### **LiDAR Quality Assessment Report**

Materials Received: 3/27/2012	Project Type: Donated Data
	Project Description:
Project ID:	LiDAR generated point cloud acquired in
AL_CoffeeDaleGenevaCo_2011	January through February 2011 for a
Project Alias(es):	1823-square mile area encompassing Coffee, Dale, and Geneva Counties in
Coffee County, Dale County, and Genev

### AL\_CoffeeDaleGenevaCo\_2011

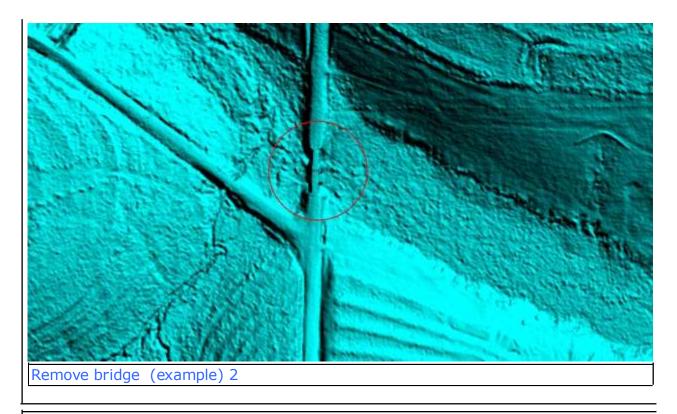
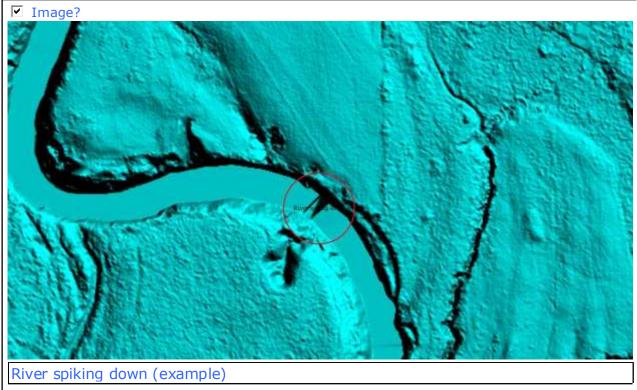
Based on this review, the USGS does not accept at this time the bare-earth DEM files.

Bare-Earth DEM Anomalies, Errors, Other Issues

Action to Contractor Date	Issue Description	Return Date
8/8/2012	fix metadata errors and deliver metadata for correct project, deliver actualy checkpoint in shapefile or excel/txt tables (if possible), Deliver Swath (if possible), Correct DEM issues cited below and in DEM Error Tags Shapfile.

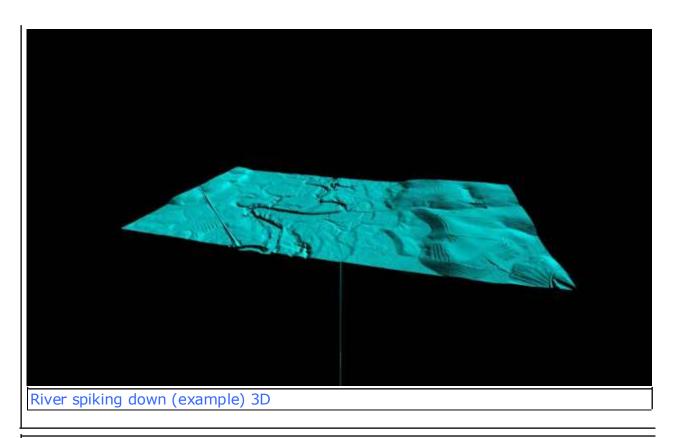
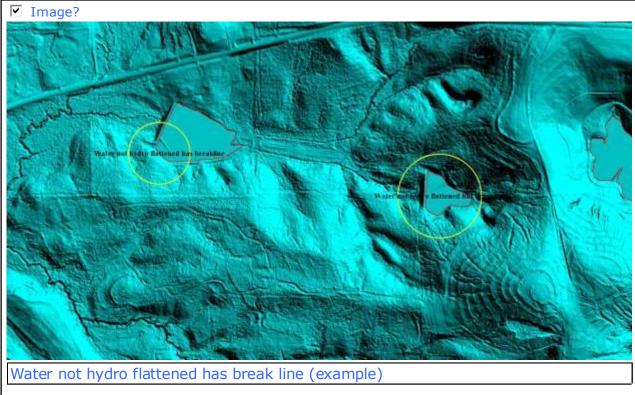
✓ Image?

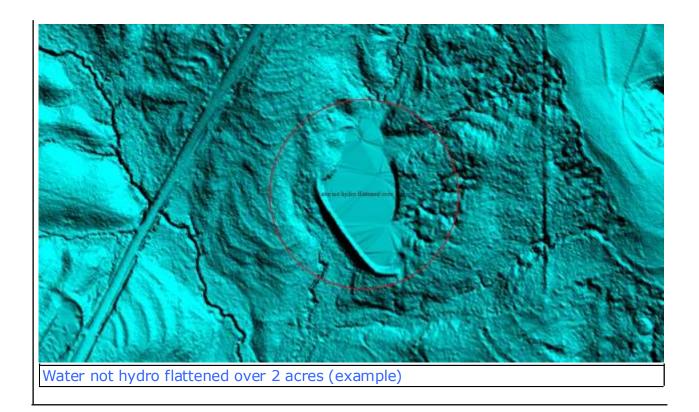
✓ Image?

The error JEPGS above are examples of errors found throughout this project. A georeferenced error shape file was created of all the errors found.
